Well Name: RED HILLS WEST 22/15 FED COM	Well Location: T26S / R32E / SEC 22 / SESW /	County or Parish/State:
Well Number: 512H	Type of Well: OIL WELL	Allottee or Tribe Name:
Lease Number: NMNM027507	Unit or CA Name:	Unit or CA Number:
US Well Number: 3002550972	Well Status: Approved Application for Permit to Drill	Operator: MEWBOURNE OIL COMPANY

Notice of Intent

Type of Submission: Notice of Intent	Type of Action: APD Change
Date Sundry Submitted: 02/24/2023	Time Sundry Submitted: 10:13
Date proposed operation will begin: 11/01/2023

Procedure Description: Mewbourne Oil Company requests to make the following changes to the APD: 1.) Change well name from Red Hills West 22 B2MD Fed Com #2H to Red Hills West 22/15 Fed Com #512H. Please see attached updated C102 2.) Change BHL from 100' FNL & 1320' FWL (Sec 22, T26S, R32E) to 100' FNL & 1320' FWL (Sec 15, T26S, R32E) - New BHL lease #NMNM 118722. Please see attached updated C102 3.) Change Csg/Mud/Cement plan. Please see attached Dir Plot, Dir Plan & Sundry Drlg Program

WELL LOCATION AND ACREAGE DEDICATION PLAT

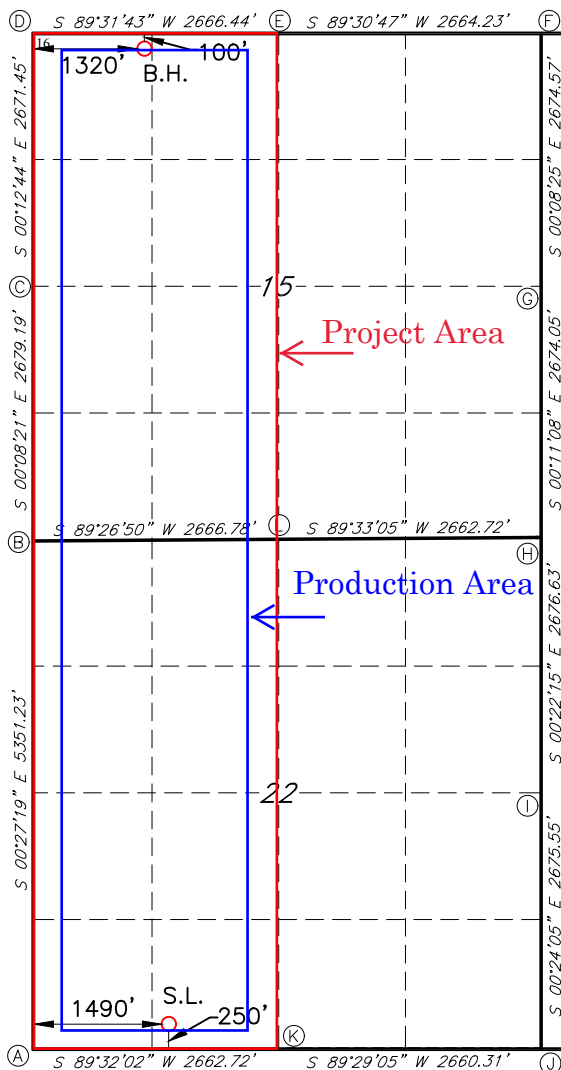
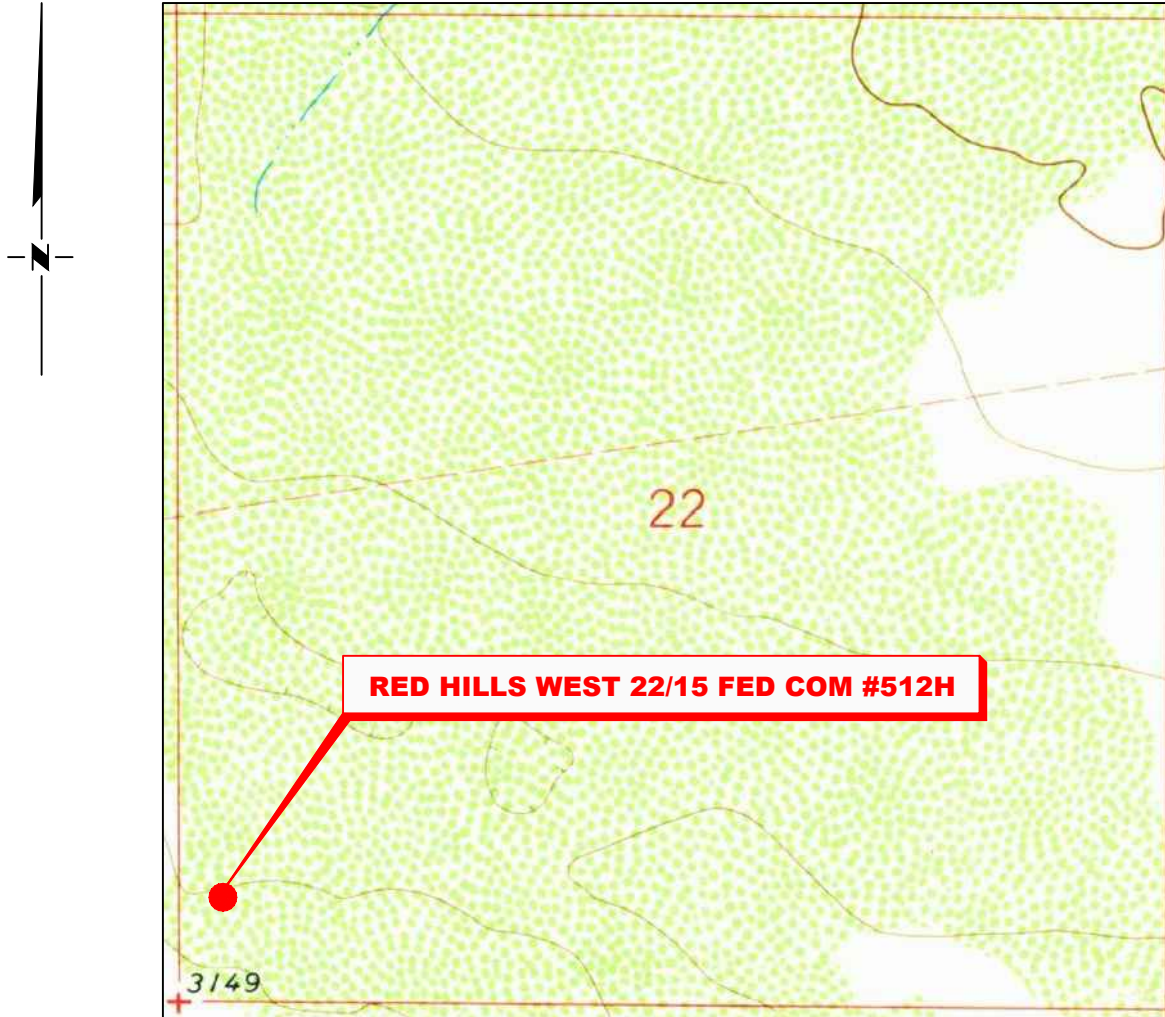
REV: NAME & BH CHANGE 02/17/23

LOCATION VERIFICATION MAP

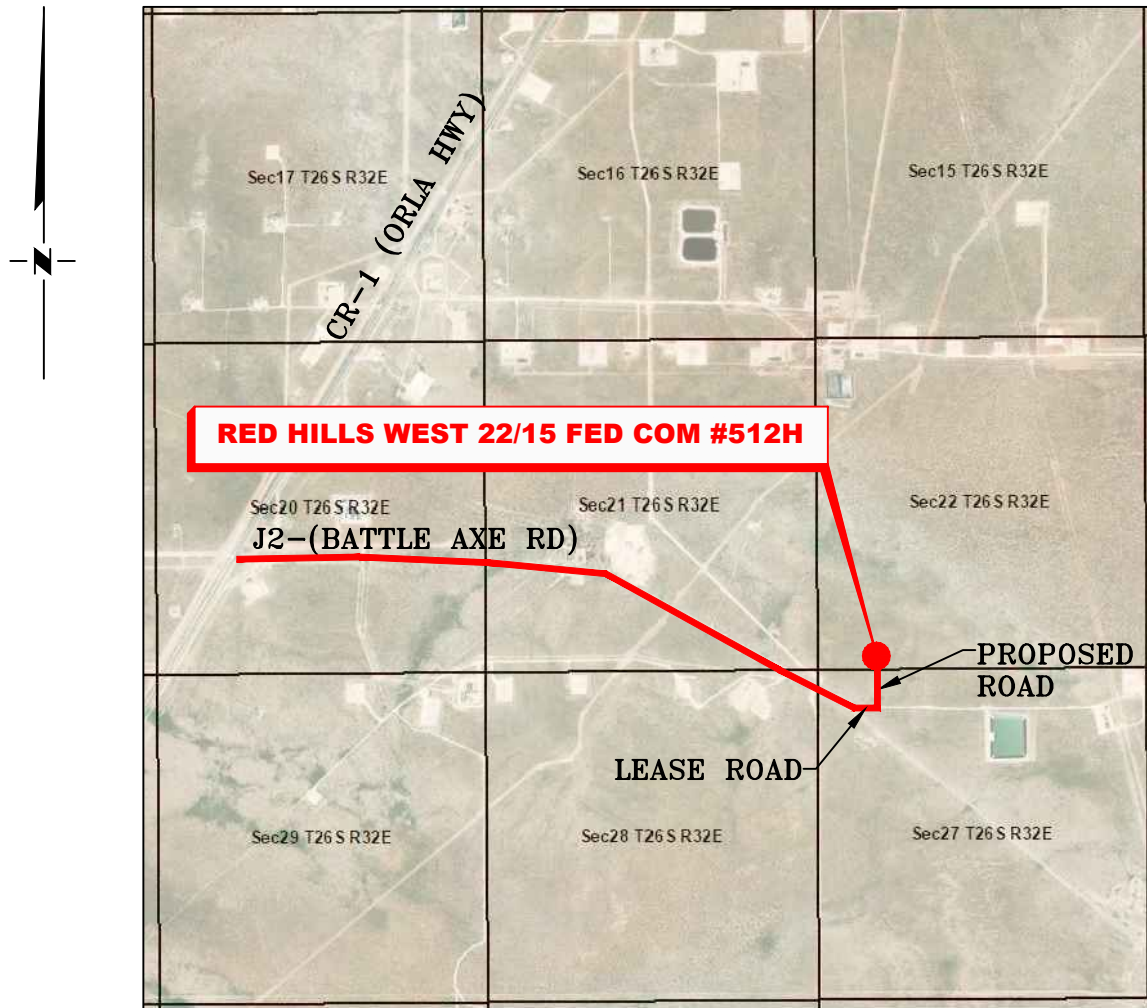
1	NAME CHANGE	2/17/23
NO.	REVISION	DATE
JOB NO.: LS21030205R1		
DWG. NO.: 21030205R1

VICINITY MAP

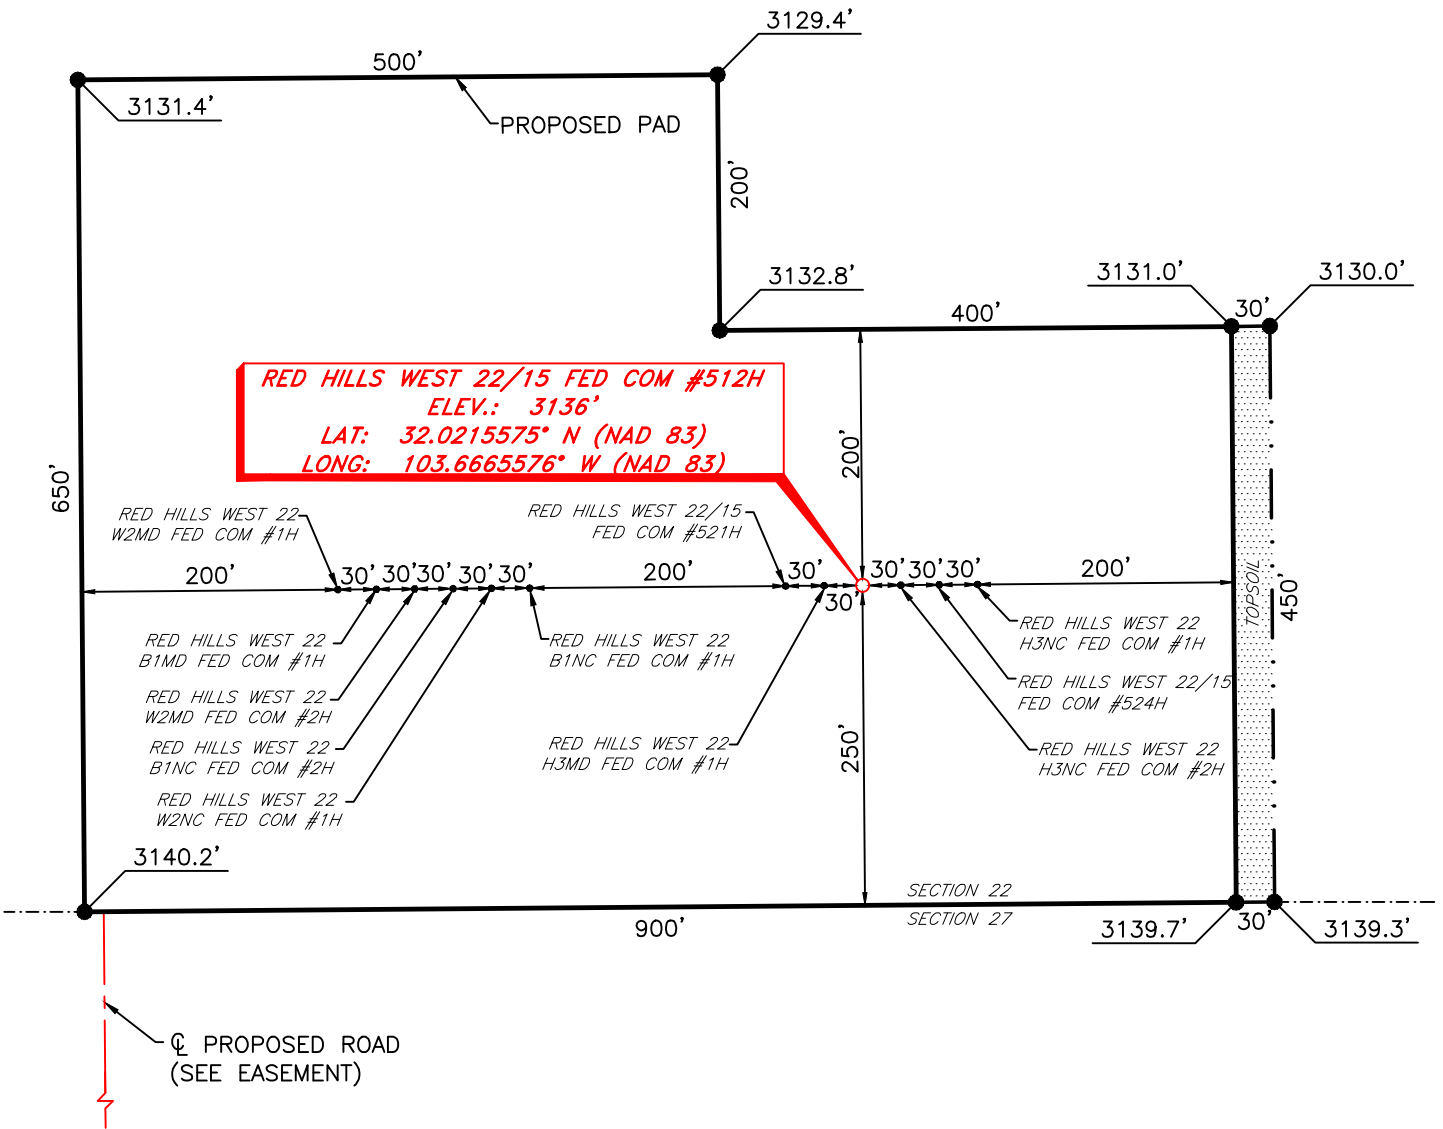
1	NAME CHANGES	2/17/23
NO.	REVISION	DATE
JOB NO.: LS21030205R1		
DWG. NO.: 21030205R1
